SUBJECT: Modifications to Electric Tariff Rule 21 to Incorporate IEEE 1547.1-2020 Test Procedures into Testing Regime for Phase 2 and 3 Requirements in Compliance with Resolutions E-5000 and E 5036

Advice 6635-E-C

Subject: Third Supplemental - Modifications to Electric Tariff Rule 21 to Incorporate IEEE 1547.1-2020 Test Procedures into Testing Regime for Phase 2 and 3 Requirements in Compliance with Resolutions E-5000 and E-5036

Figure Hh-1: Voltage and Reactive Default Settings

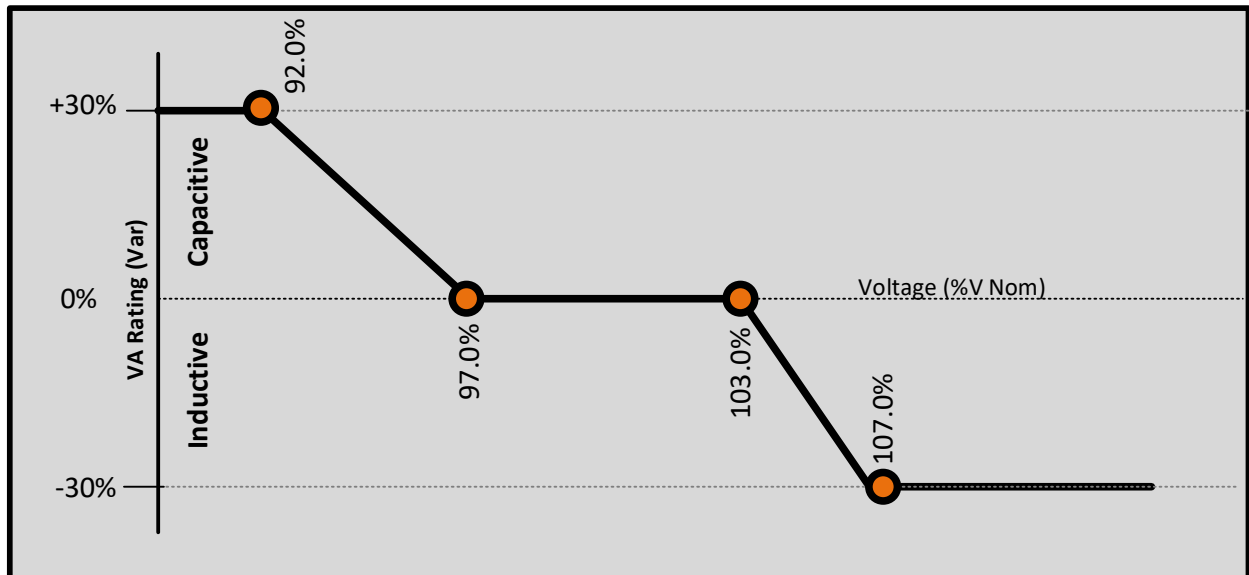
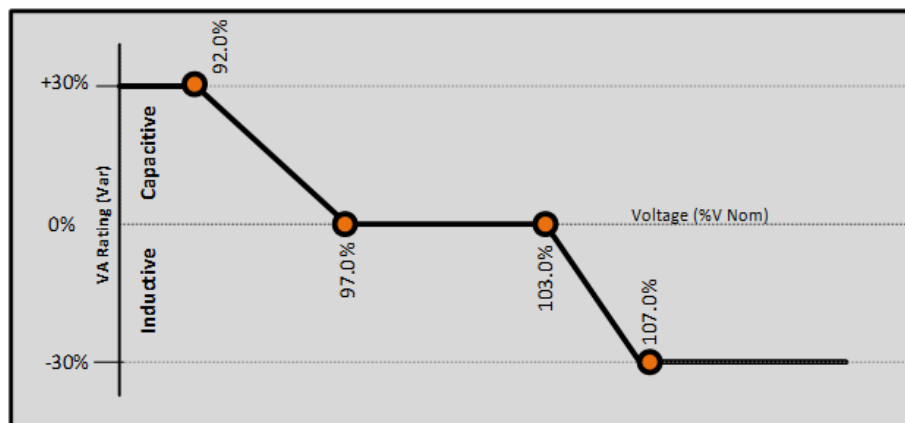
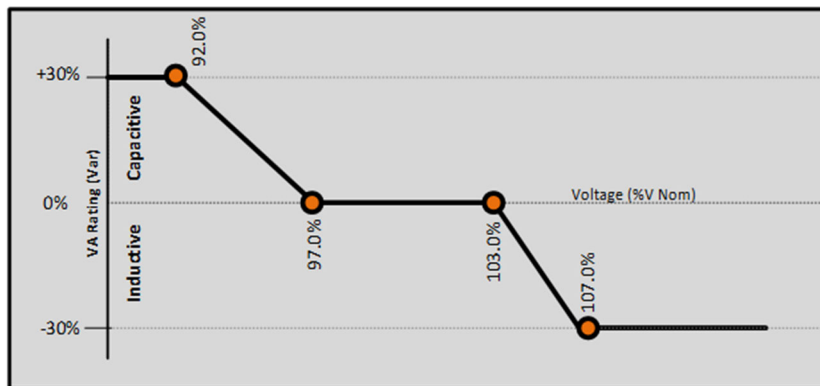
Hh-4 and Figure Hh-1 to reflect the voltage values that aligned with IEEE 1547-2018, 97.0% and 103.0%, respectively.

Figure Hh-1 will be replaced with the diagram below to align with IEEE 1547-2018 requirements:

Figure P-1: Voltage and Reactive Default Settings

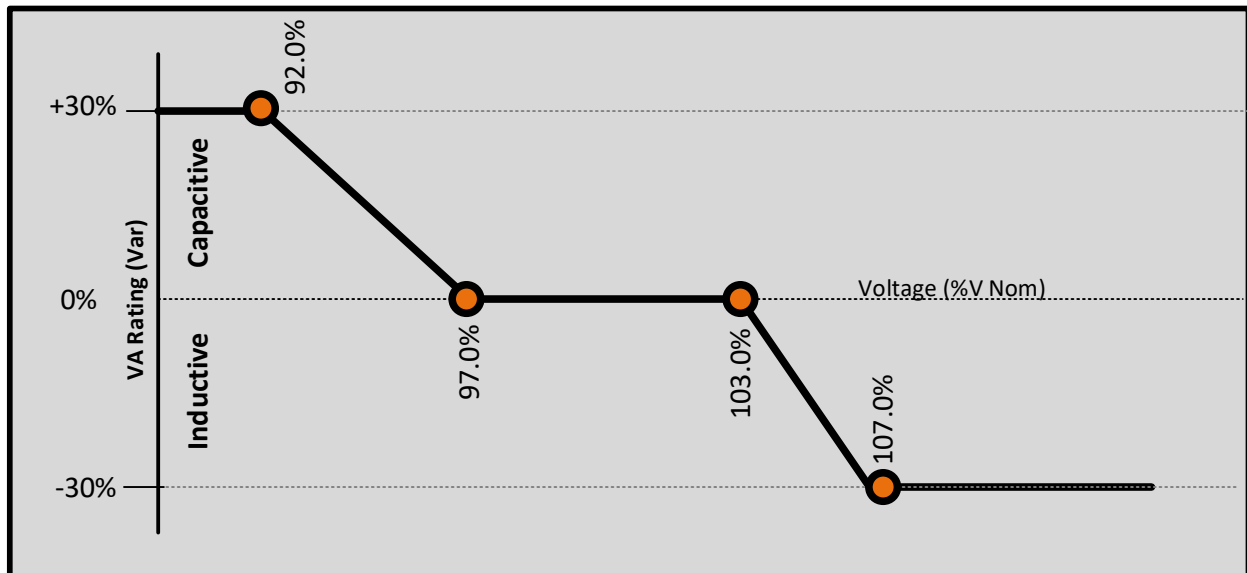
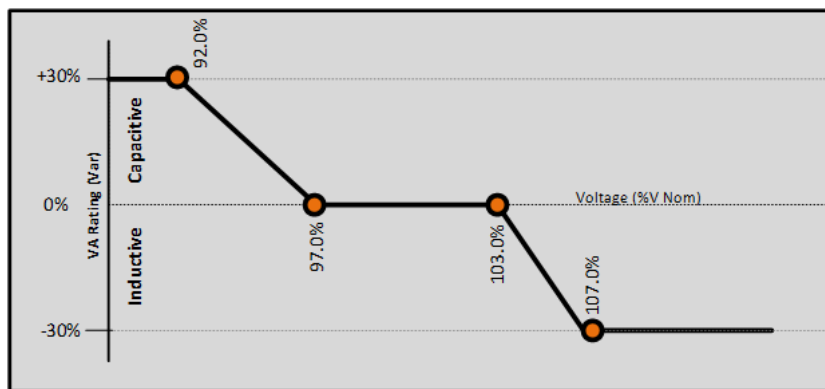
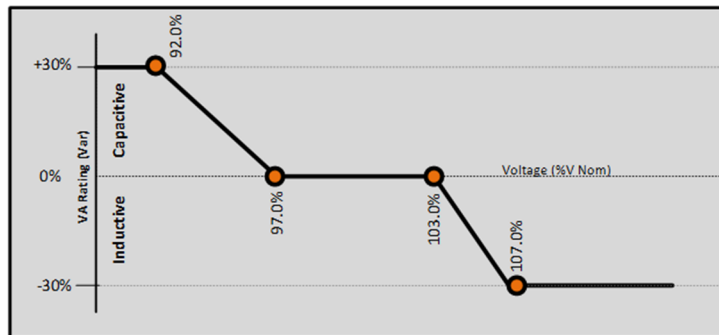
Figure P-1 will be replaced with the diagram below to align with IEEE 1547-2018 requirements:
